RECORD OF DECISION

Magna Metals
State Superfund Project
Cortlandt, Westchester County
Site No. 360003
June 2011

Prepared by
Division of Environmental Remediation
New York State Department of Environmental Conservation

FIGURE
7

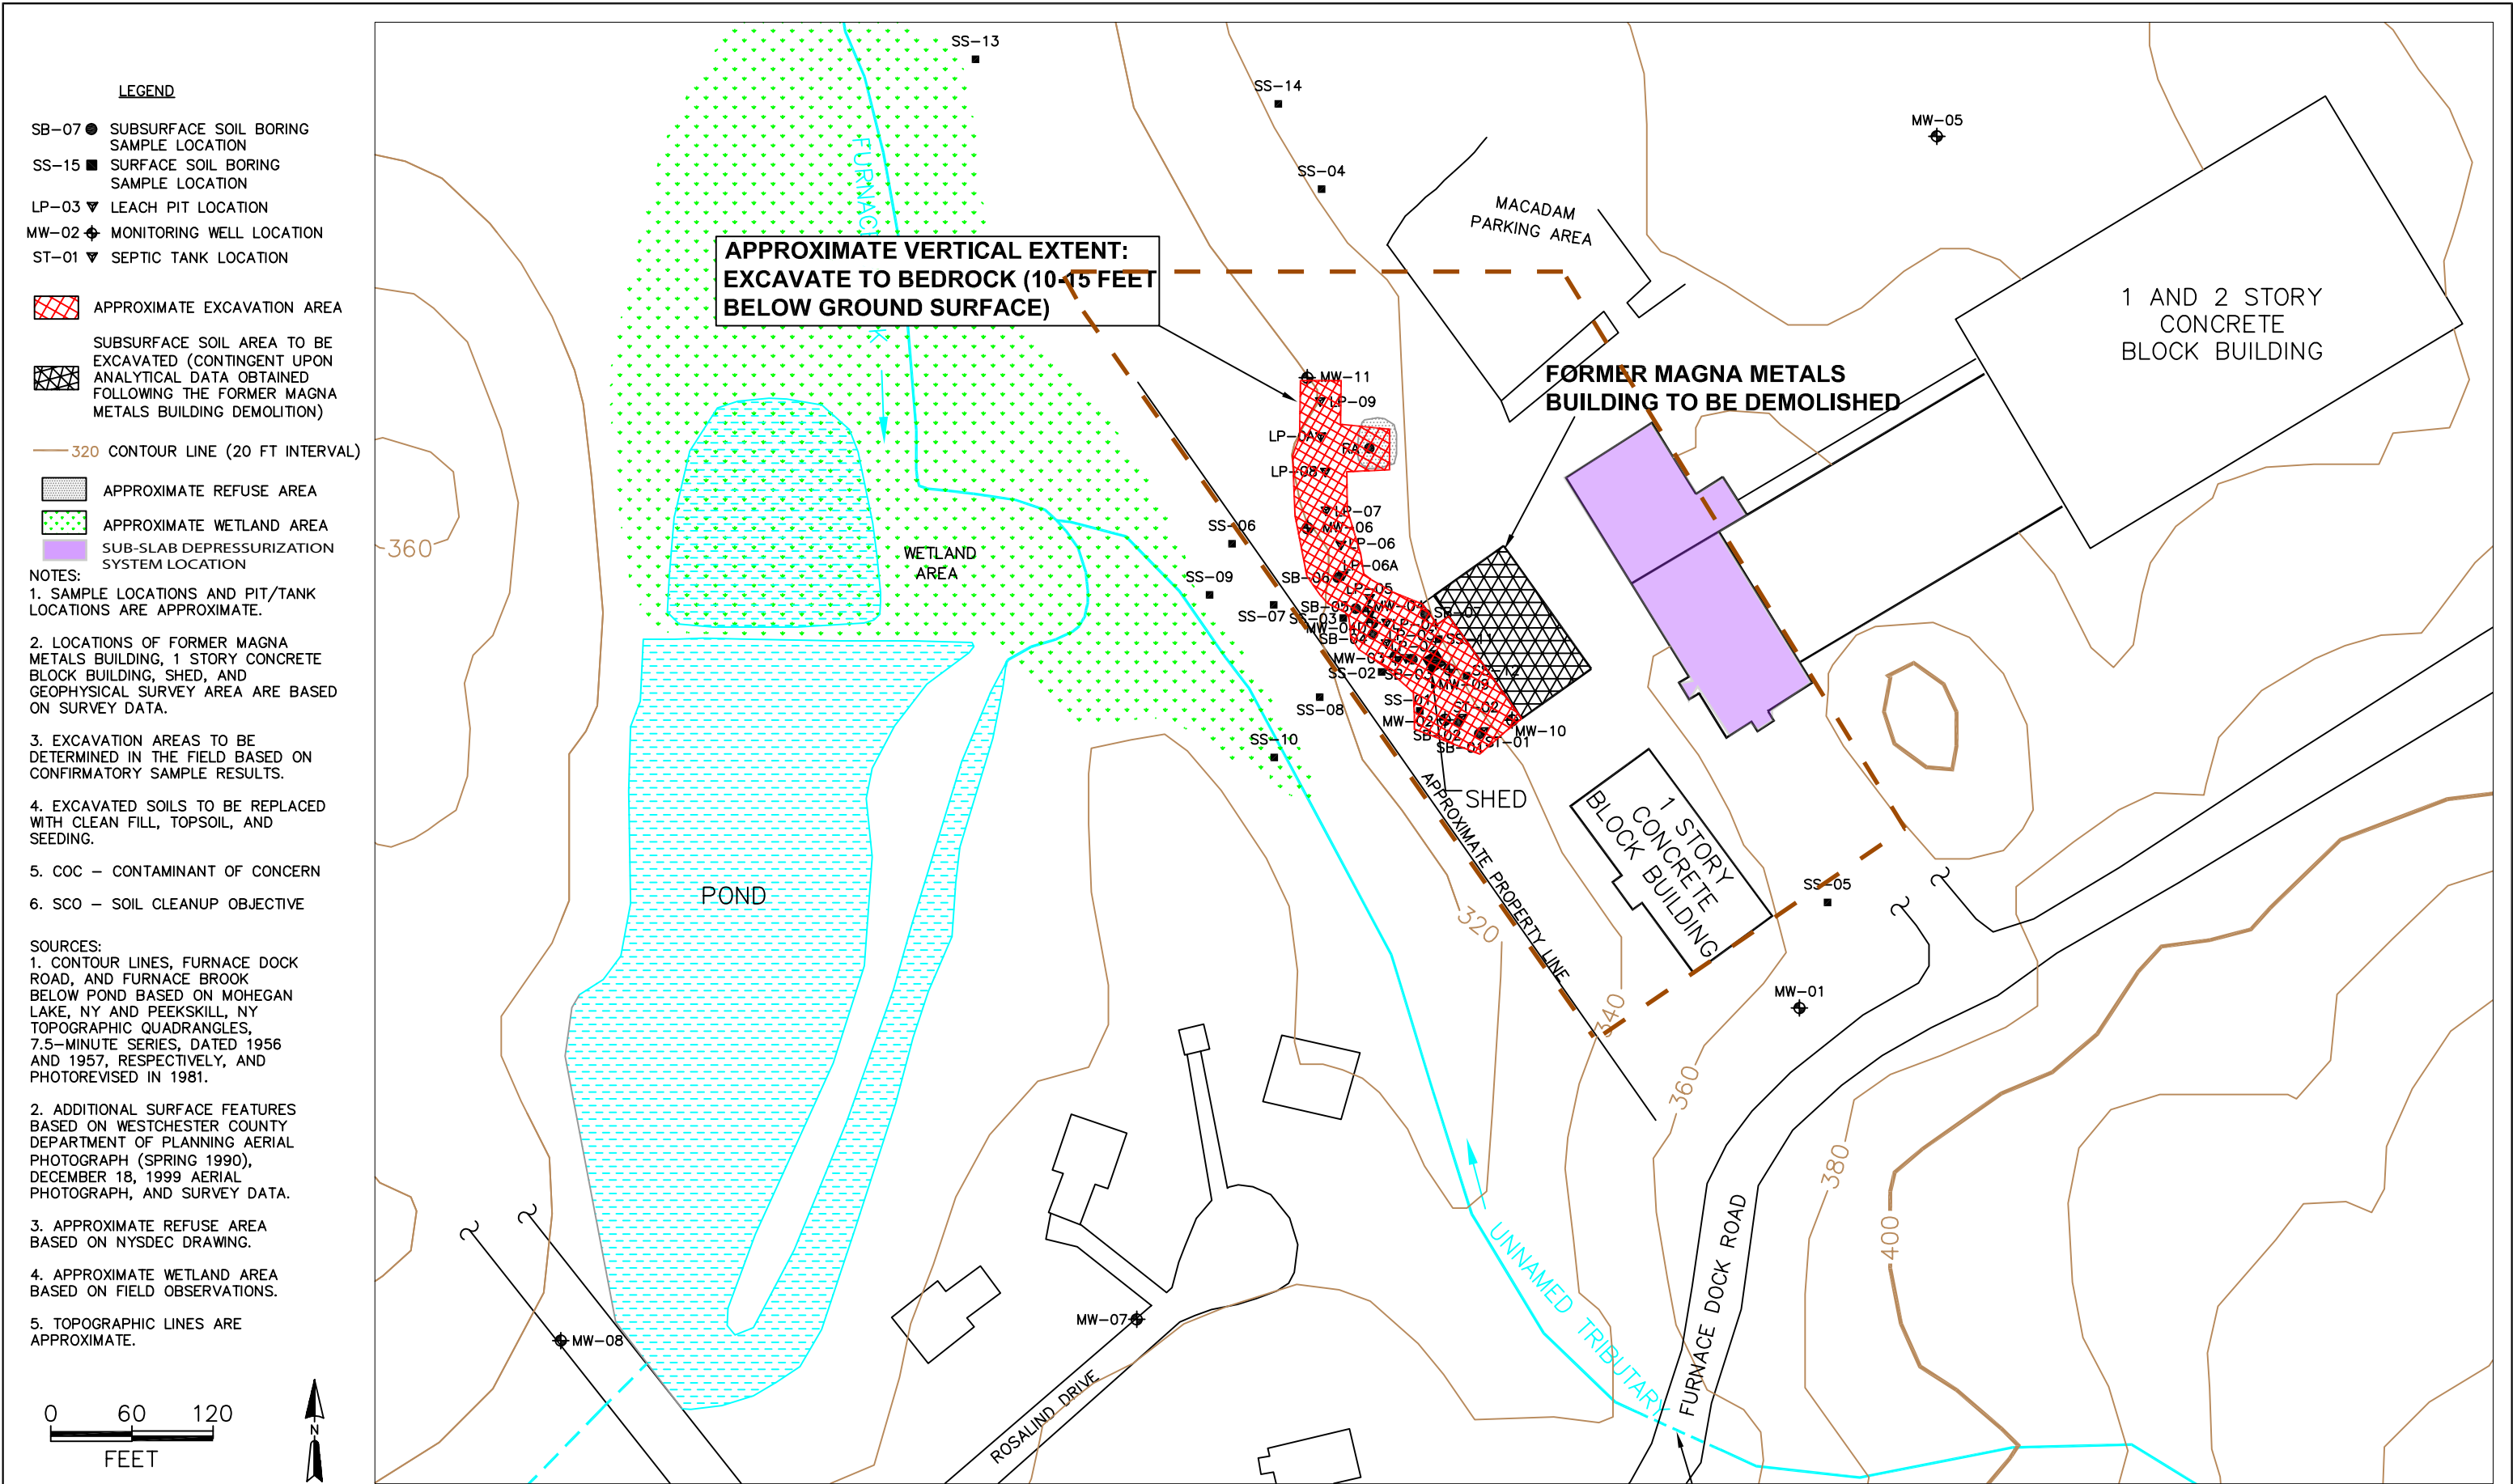
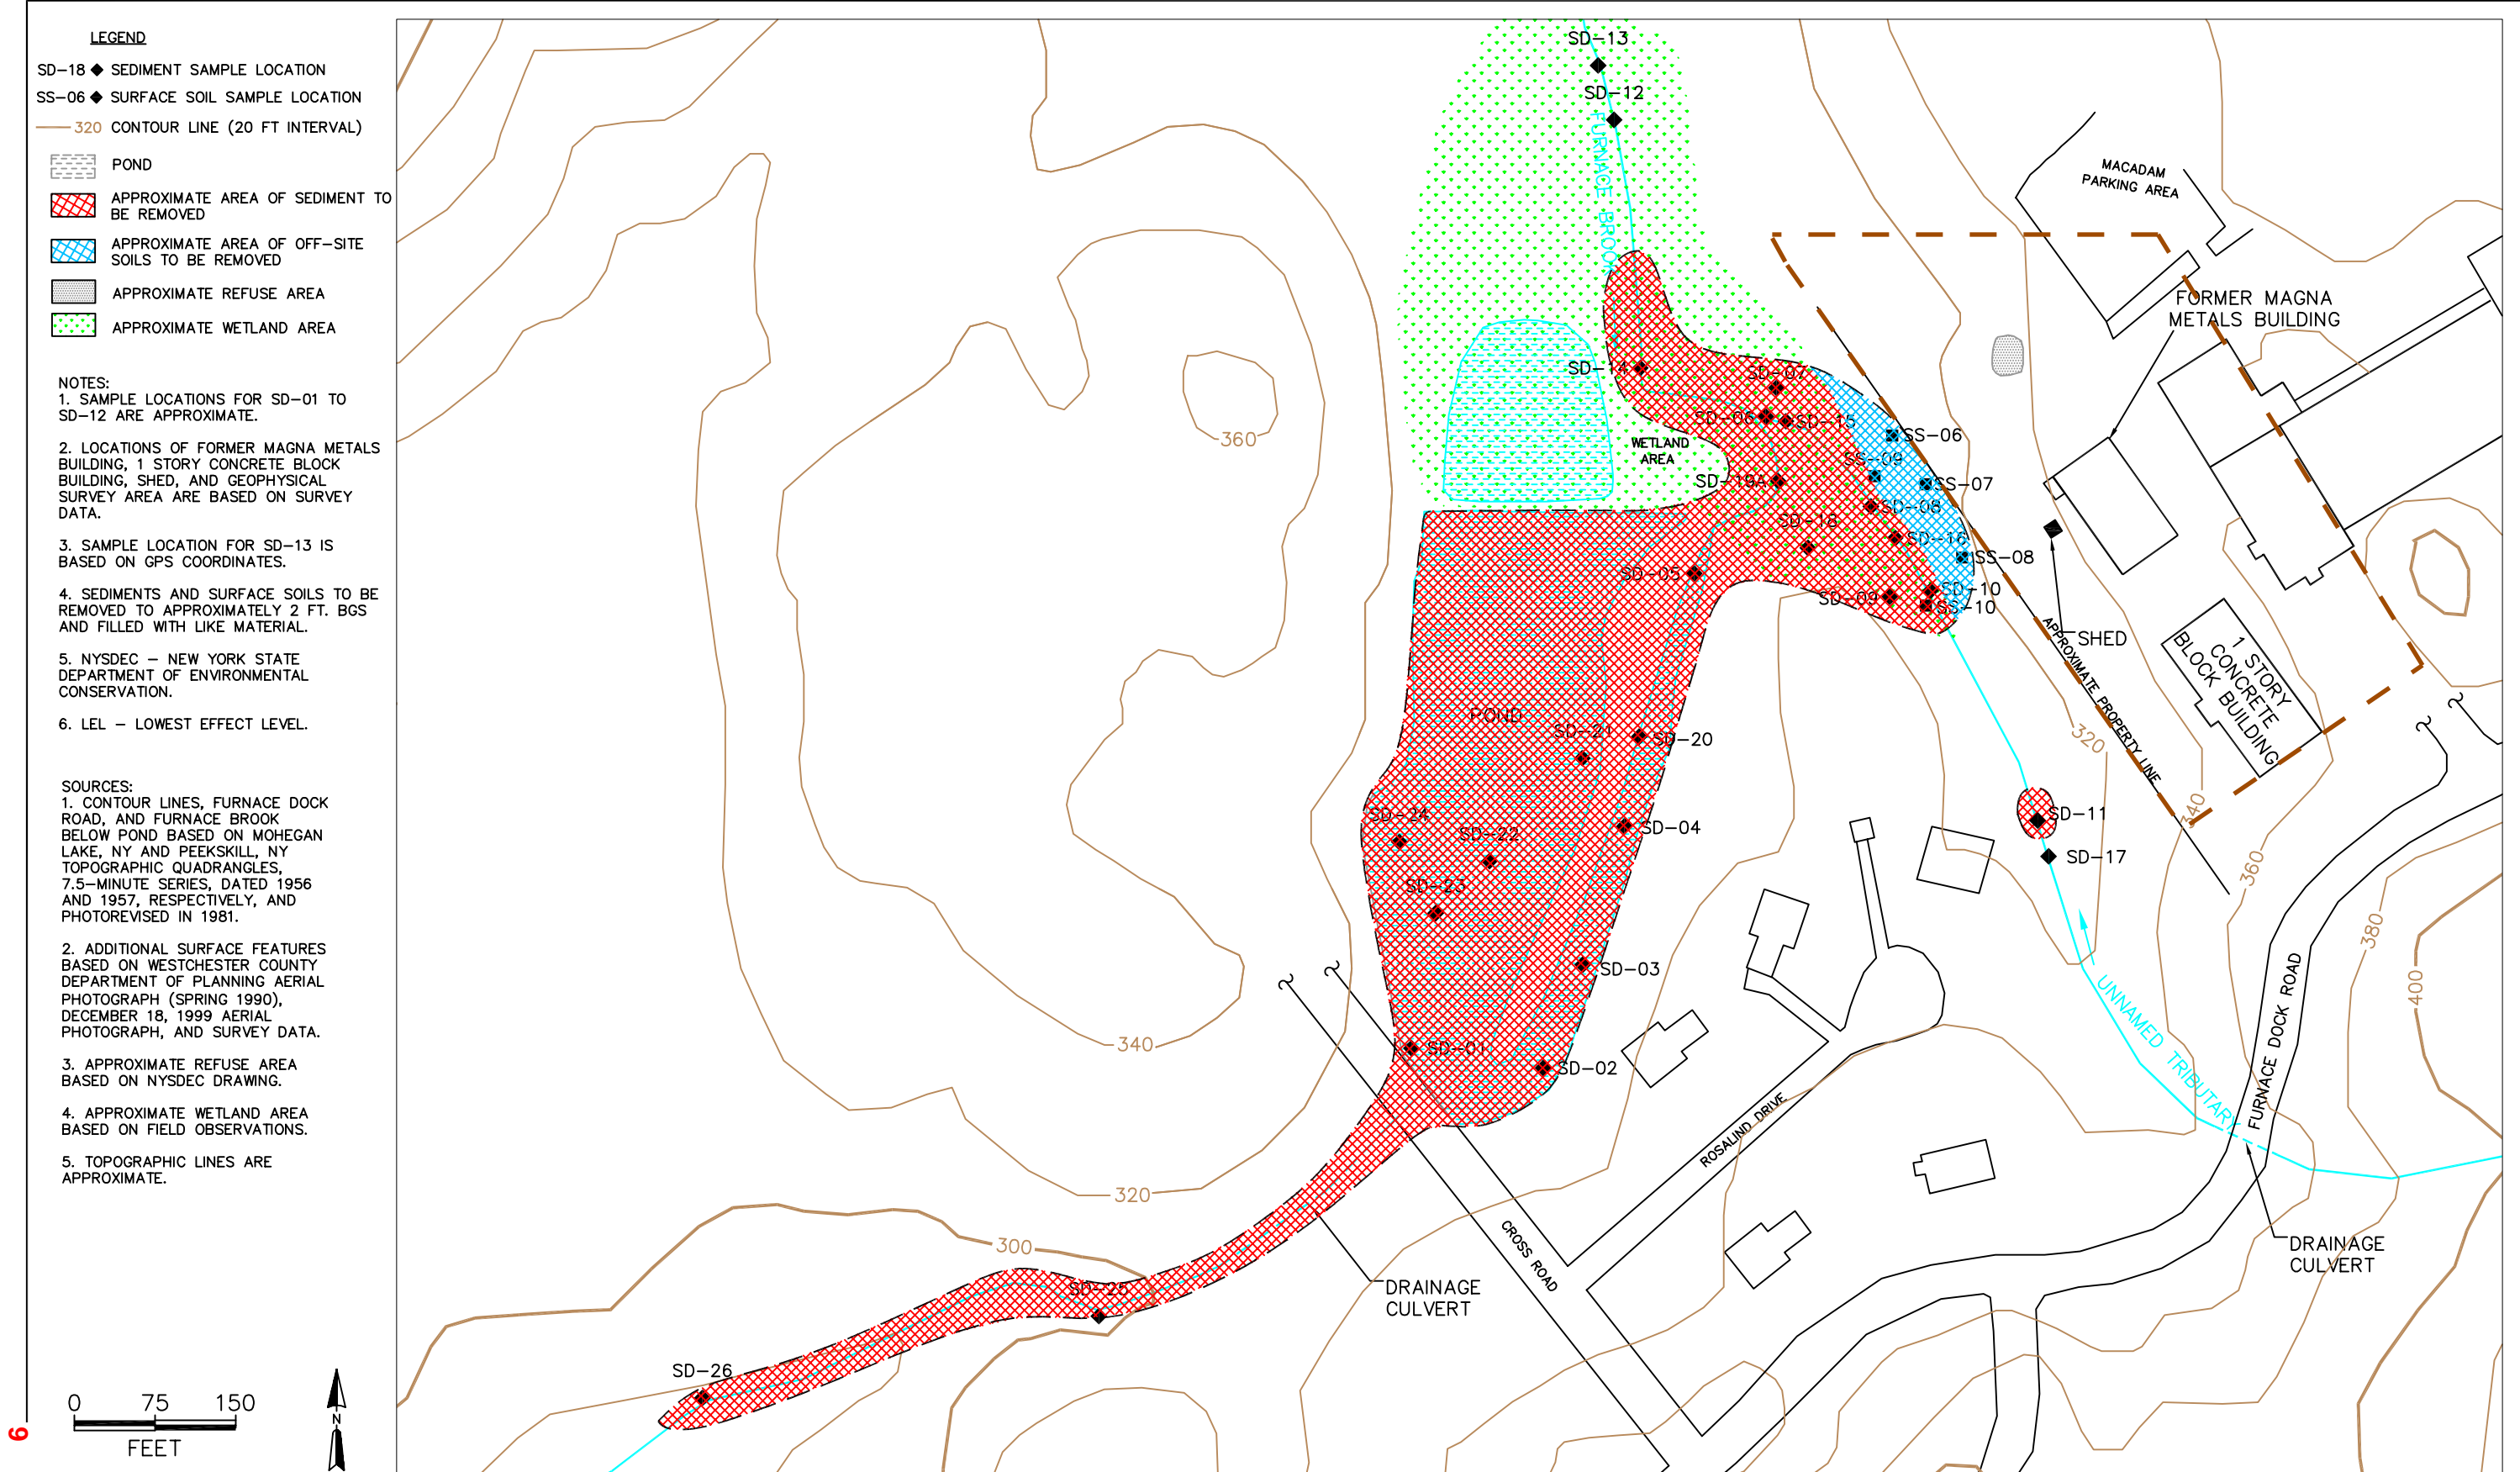
COMMENT 19: Were other buildings, on site and/or off-site tested for soil vapor?

RESPONSE 19: At the request of the Department, soil vapor between the three buildings on the Magna Metals site was sampled and analyzed. The consultant also sampled the soil vapor underneath the slabs (i.e., the "subslab vapor") of the occupied building on site, the Polymedco Bldg. (See Figure 7). Neither soil vapor nor subslab vapor samples were collected off-site.
